Post-Concrete Pour Slab Report - After Frame & Bricks Installed.

Inspection Date: 25 Aug 2020

Property Address: Craigieburn Area

Report Type: New Home Construction

Non Compliant 2.02

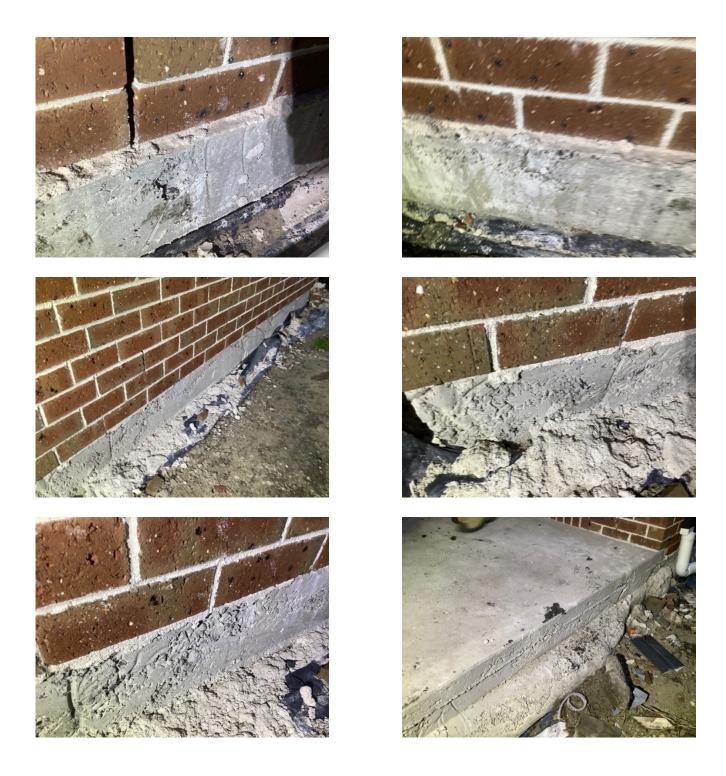
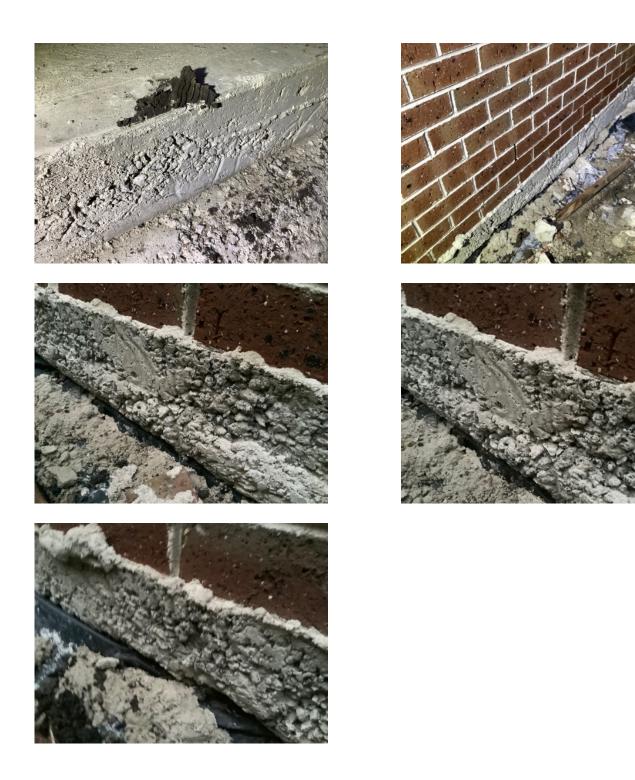
Finding: Compaction Of The Slab.(Honeycomb Evident)

At the time of the inspection it appears that the slab has not been mechanically compacted

Looking at the side of the slab, it appears evident that the slab has not been vibrated to all parts. The honeycomb effect that is made up of hundreds of air pockets is what should not be

Had this slab been vibrated to all parts, then this honeycomb effect would not be present and the concrete would have a smooth like finish.

The defect is that if it has not been done to the outer skin of the exposed areas, then the likely

hood is that the internal of the slab has the same honeycomb effects as well and if this is the case then the density of the concrete will be compromised.

- -/ Seek engineering advice.
- -/ Seek a Compressive Strength Test to check the MPA strength after a certain period of cure time.
- -/ Sample the slab via a core hole or several core holes that are taken by a NATA accredited testing agency. Note the NATA testing agency must take the samples to ensure a reliable chain of evidence.
- -/ Share the results with my client and the engineer.
- -/ Upon all the results a conclusion that meets the AS 2870.

Non Compliant 2.03

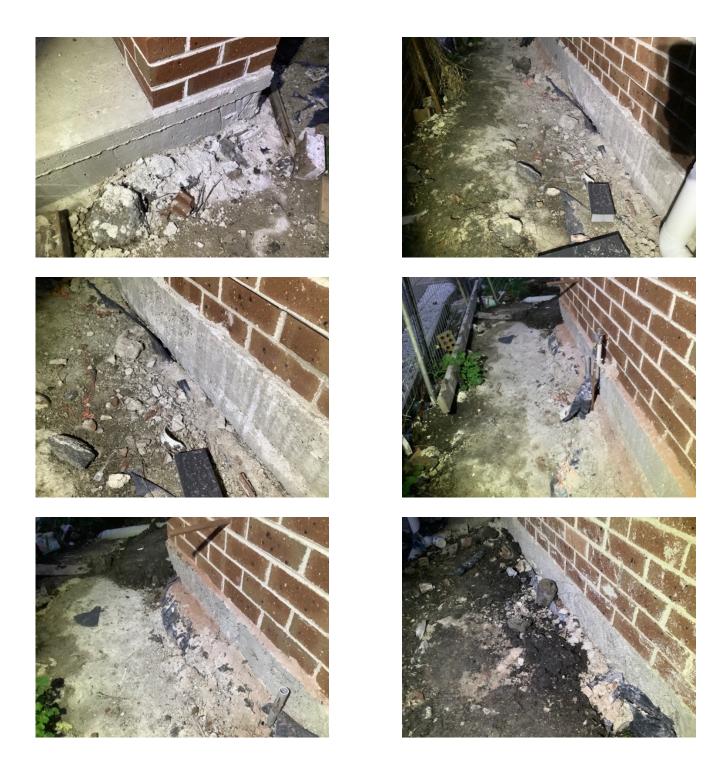
Finding: Slab Over Pour - Not Acceptable.

The slab has been installed with what is known as over pour.

The over pour will affect the home owner's ability to install paving and other landscaping.

The over pour will need to be removed. This will require:

- -/ Seek engineering process and design for rectification of this defect.
- -/ Document same.
- -/ Send the engineering to the site surveyor for approval.
- -/ Have the site surveyor witness the repair of the slab to ensure that the builder has carried out the works in accordance with the process's and rectification statements in the engineering documentation.
- -/ Supply a copy of all to my client as per section 26 of the Domestic building contracts Act 1995.
- -/ Satisfy the defect has not been hidden by placing soil over the edge beam of the over poured slab.

Non Compliant 2.04

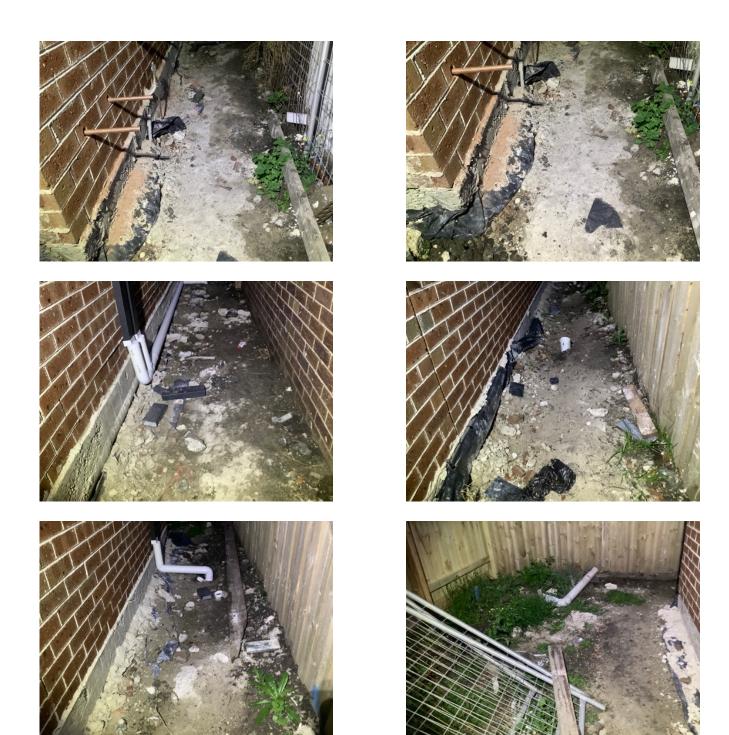
Finding: Builder Concrete Waste - Remaining

It was noted that there is excessive amount of concrete (builder waste) on the site in various areas. All builders waste must be removed as per the contract.

The builder must use all endeavours to ensure that the site is safe and left clean whilst in construction and a clean, builders waste free site prior to final handover as per the building act and contractual agreements.
